# SERVICE BULLETIN # 00242

**SUBJECT:** Incorrect Vending In 20+ Due To Bad Optic Sensor Boards

**MODELS:** All 20+ Models

Optic Sensor Board

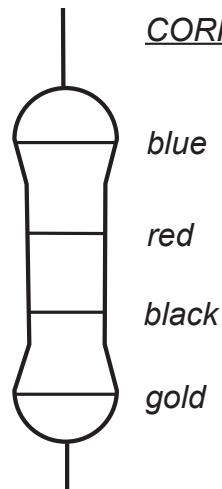
**HOW TO IDENTIFY BAD OPTIC SENSOR BOARDS:** At positions R210 and R310 (adjacent to positions Q21 and Q31, respectively), there are two resistors. These resistors each have four colored bands around them. The **correct** resistors will have a black band around them; the **incorrect** resistors will have a brown band. (See illustrations below.) If the optic sensor board has the incorrect resistors, replace the board.

Check the band colors on these resistors:
